# **Supporting material for Clause 85 comments submitted**

**Chris Di Minico  
MC Communications  
cdiminico@ieee.org**

CR4 and CR10 cable assembly IL specifications

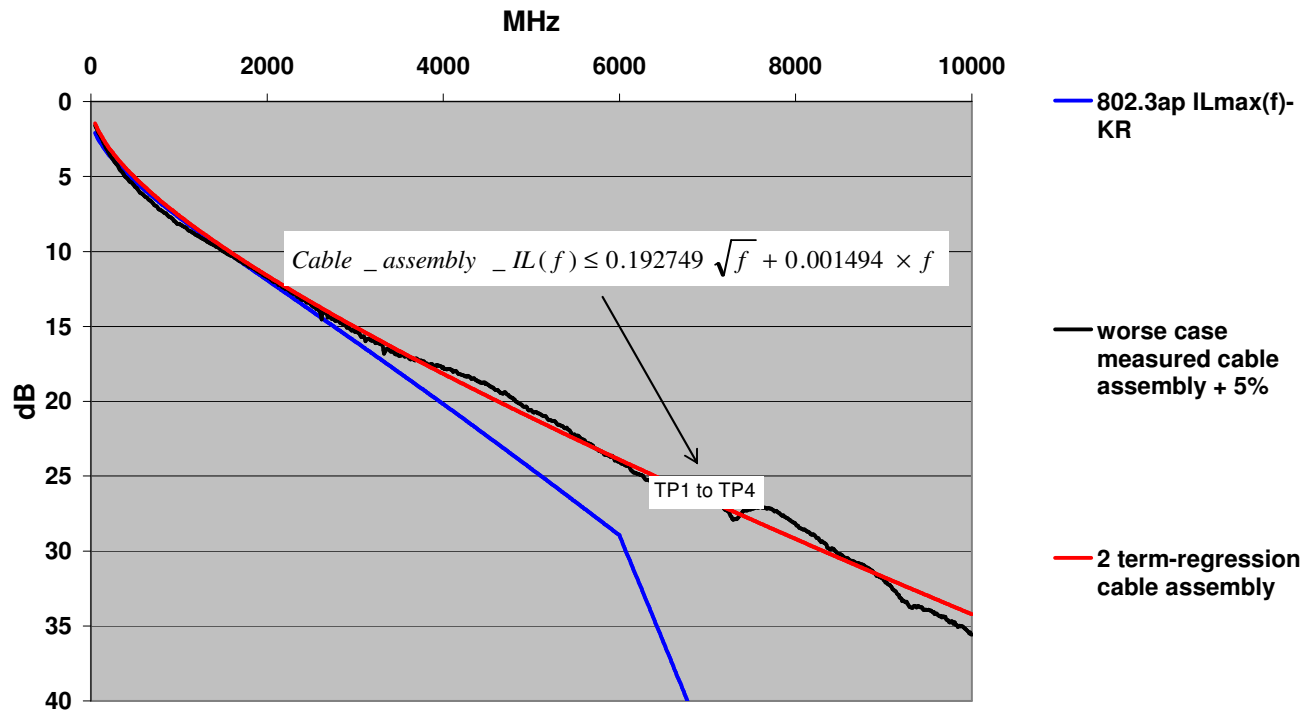
Provide values for TBDs in cable assembly insertion loss (85-1) for  $\sqrt{f}$  and  $f$ . Remove  $1/\sqrt{f}$  term. Add TBD cable assembly insertion loss equation as contributions from IL and power sum crosstalk to ICR are still under study.

Insertion Loss (f) =  $0.192749 \cdot \sqrt{f} + 0.001494 \cdot f$  TBD dB. Remove  $1/\sqrt{f}$  term. Given the CR4 and CR10 bandwidth compared to CX4 the  $1/\sqrt{f}$  loss function term is not necessary as a regression term.

### CR4 and CR10 cable assembly RL specification

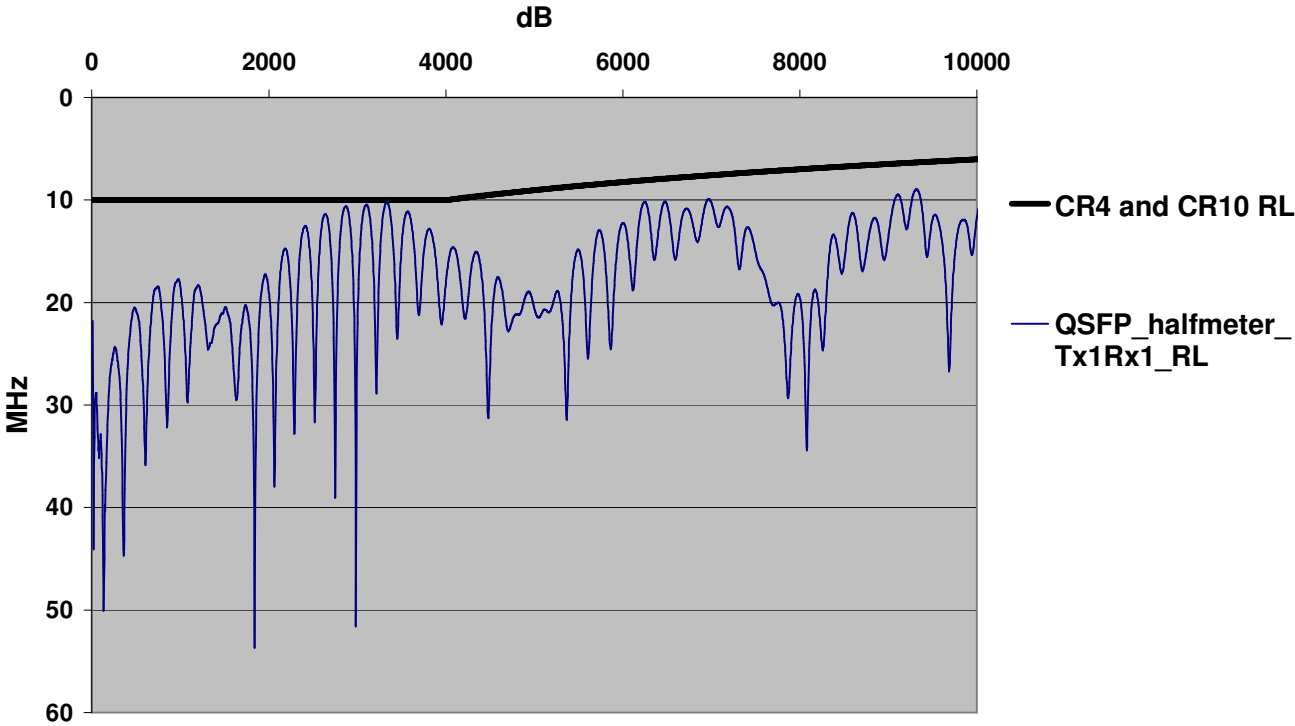
The return loss (in dB with f in MHz) of each pair of the 40GBASE-CR4 and 100GBASE-CR10 Cable assembly shall be:

Return\_loss(f)= 10 dB for 100 MHz <= f < 4000 MHz

Return\_loss(f)=10-10\*log(f/4000) for 4000 MHz <= f <= 10000 MHz

## 802.3ap ILD vs CR4 and CR10 ILD 0.5m and 10m cable assembly

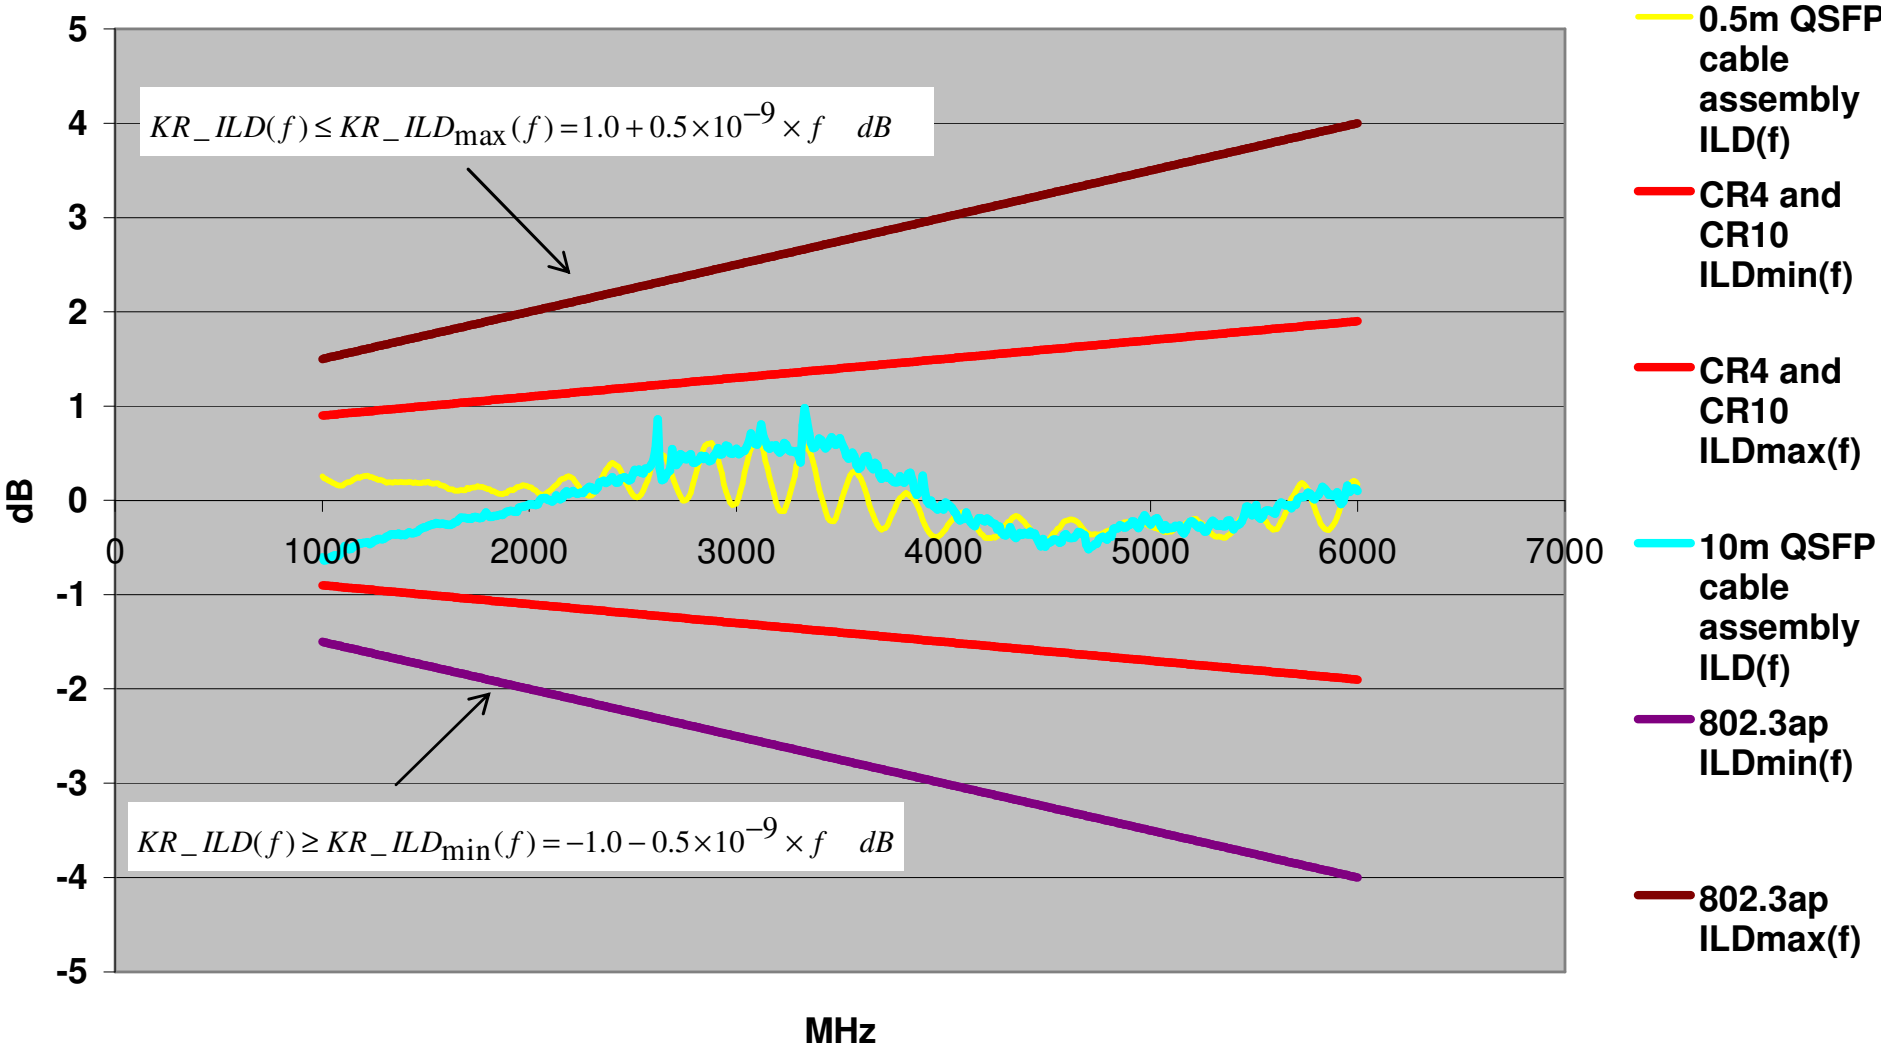
Add cable assembly ILD specifications to limit cable assembly ILD. Add TBD to equation as contributions from IL and power sum crosstalk to ICR under consideration.

The cable assembly insertion loss deviation is the difference between the cable insertion loss and the fitted insertion loss determined using Equation (85-x).

The ILD shall be within the region bounded by the following equations:

$$ILD_{max} = 0.7(TBD) + 0.2(TBD) \cdot 10^{-9} \cdot (f \cdot 10^6) \quad TBD \text{ dB}$$

$$ILD_{min} = -0.7(TBD) - 0.2(TBD) \cdot 10^{-9} \cdot (f \cdot 10^6) \quad TBD \text{ dB}$$

$$1000 \text{ MHz} \leq f \leq 6000 \text{ MHz}$$

# Insertion to crosstalk ratio Channel = 10m cable assembly + 8 inches of PCB differential trace loss

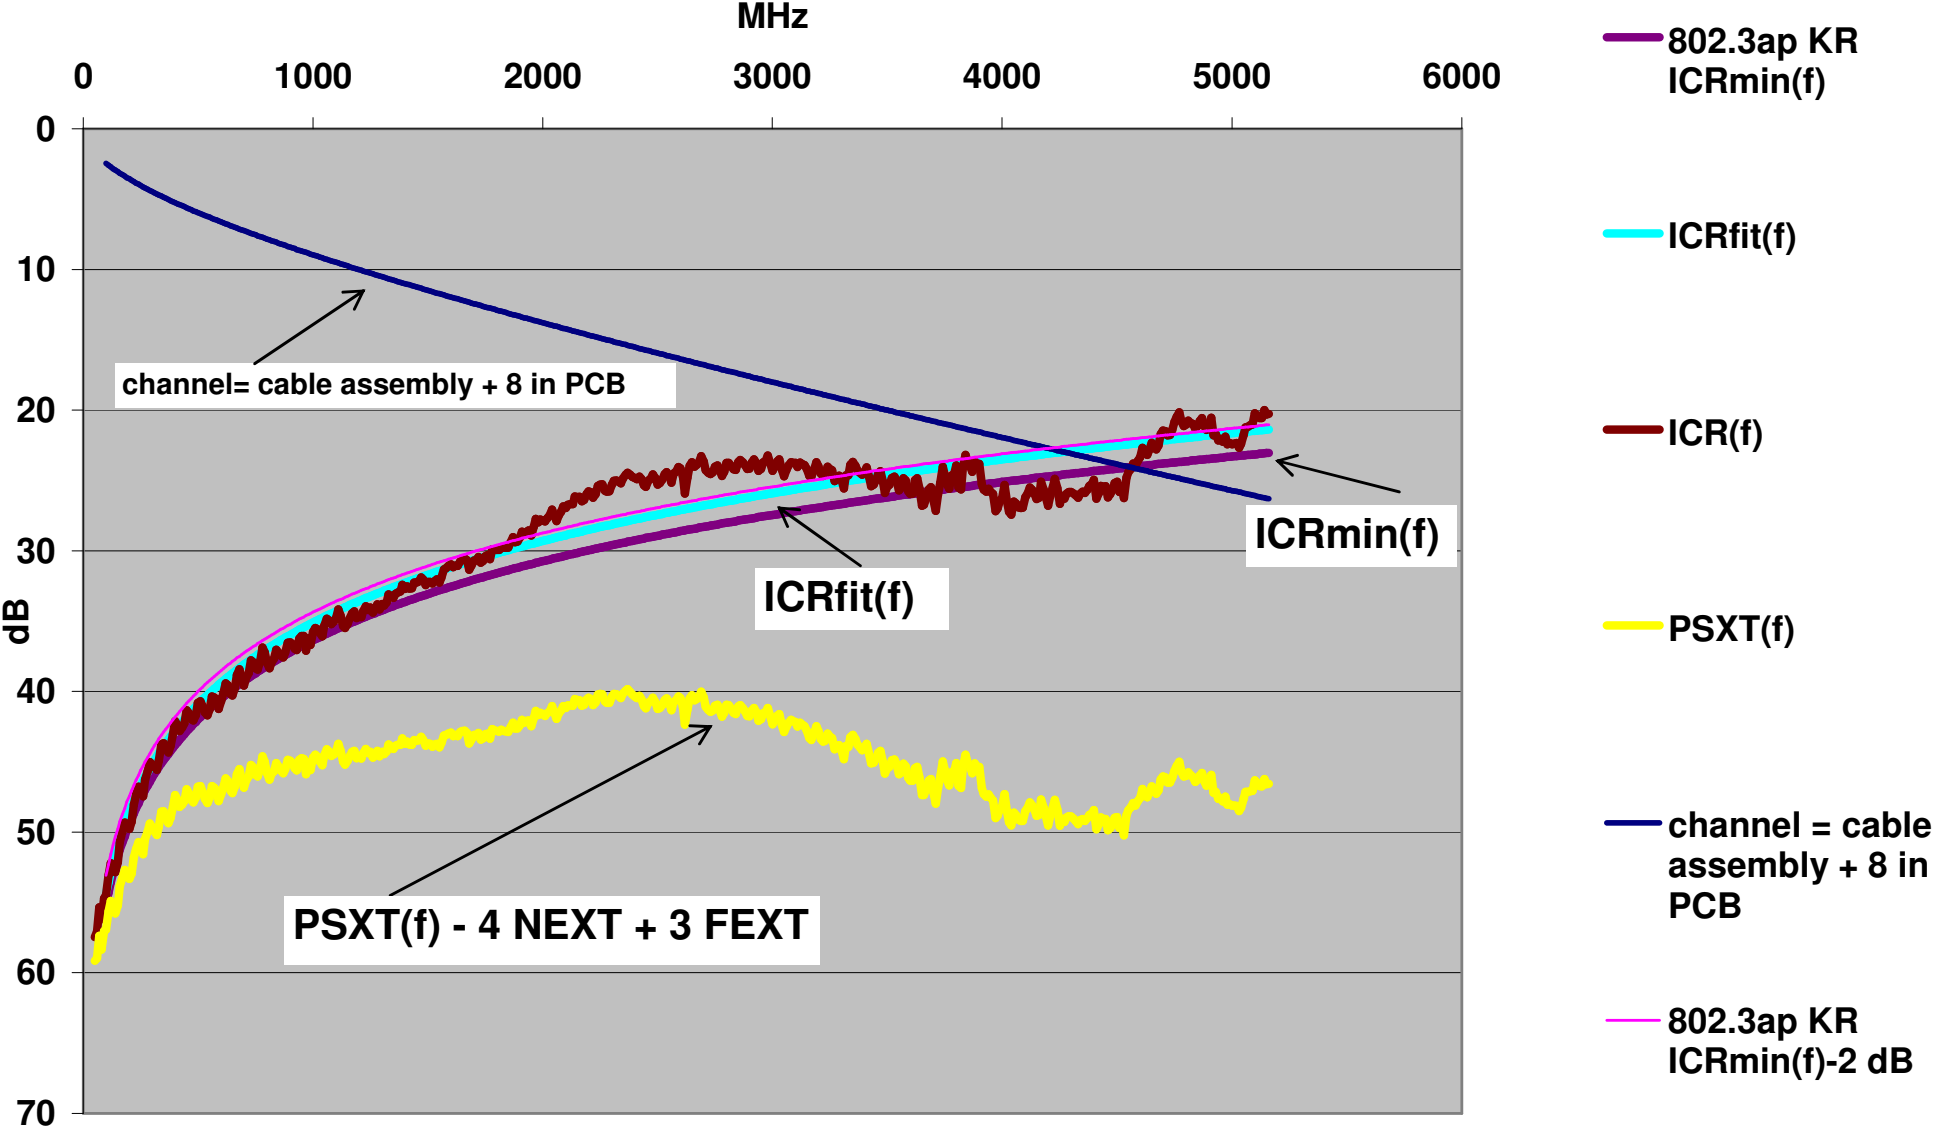
**Add cable assembly ICR specification to limit the total multi-disturber cable assembly crosstalk noise. Add TBD to equation as contributions from IL and power sum crosstalk to ICR under consideration.**

**The cable assembly insertion loss to crosstalk ratio (ICR) is the ratio of the cable assembly insertion loss to the total cable assembly crosstalk loss determined using Equation (89.xx).**

$$\text{ICR}(f) = -\text{IL}(f) + \text{PSXT}(f) \text{ (TBD) dB}$$

**Add equation:  $\text{ICR}_{\text{fit}}(f) \geq \text{ICR}_{\text{min}}(f) = 23.3 - 18.7 \cdot \text{LOG}((f \cdot 10^6) / (5 \cdot 10^9)) - 2.5$  (TBD) dB**

**Note: 2.5 dB of the 3 dB signal-to-noise ratio penalty related to insertion loss deviation embodied in 802.3ap  $\text{ICR}_{\text{min}}$  is applied as 2.5 dB  $\text{ICR}_{\text{min}}$  margin to account for reduction in ILD penalty for CR4 and CR10**

## Differential PCB trace loss 8 inches (Amax)

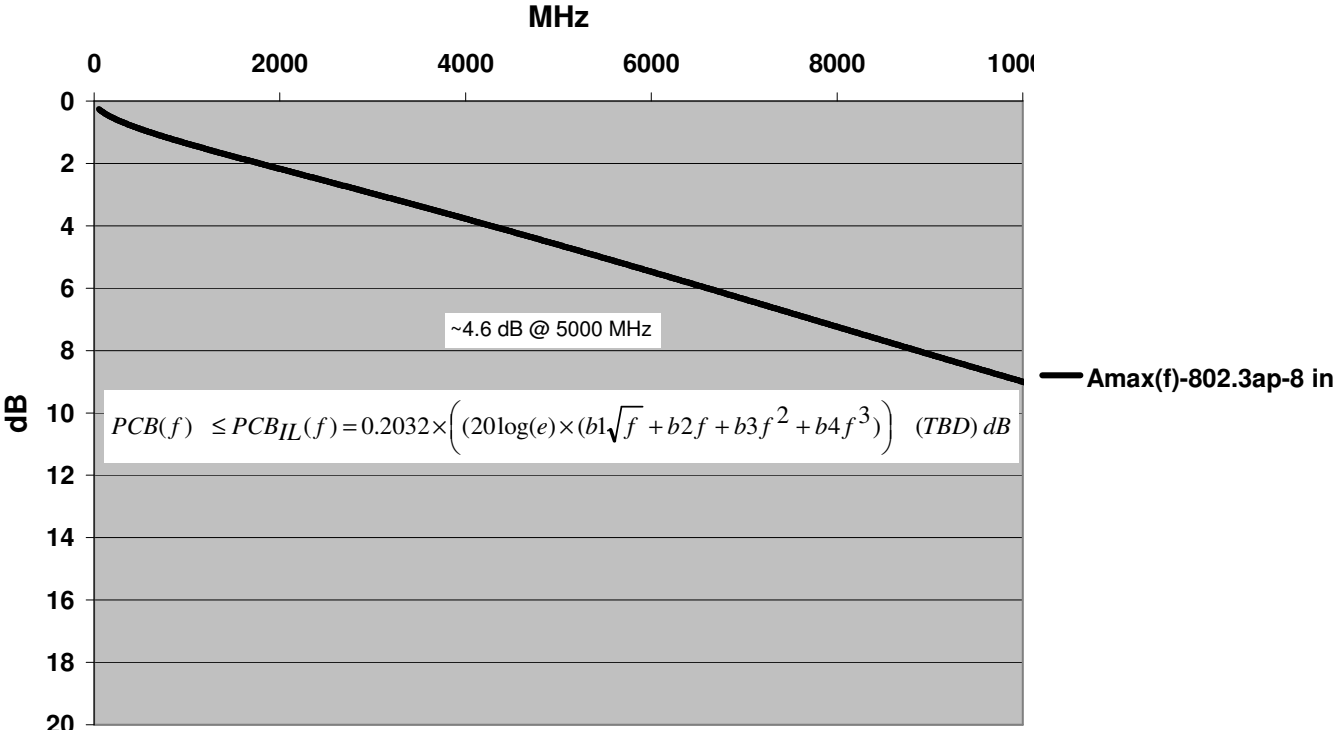
The maximum insertion loss (in dB with f in MHz) for the transmitter and receiver differential controlled impedance printed circuit boards for each differential lane shall be:

Insertion Loss(f) ≤ (0.2032) \* [20 \* log(e) \* (2.00E-05 \* sqrt(f \* 10^6) + 1.1E-10 \* (f \* 10^6) + 3.2E-20 \* ((f \* 10^6)^2 + 1.2E-30 \* (f \* 10^6)^3)] TBD dB for all frequencies from 100 MHz to 6000 MHz.

Insertion Loss(f) represents 8 inches (0.2032 m) of the maximum fitted attenuation (Amax) due to trace skin effect and dielectric properties as defined in Annex 69B.4.2.
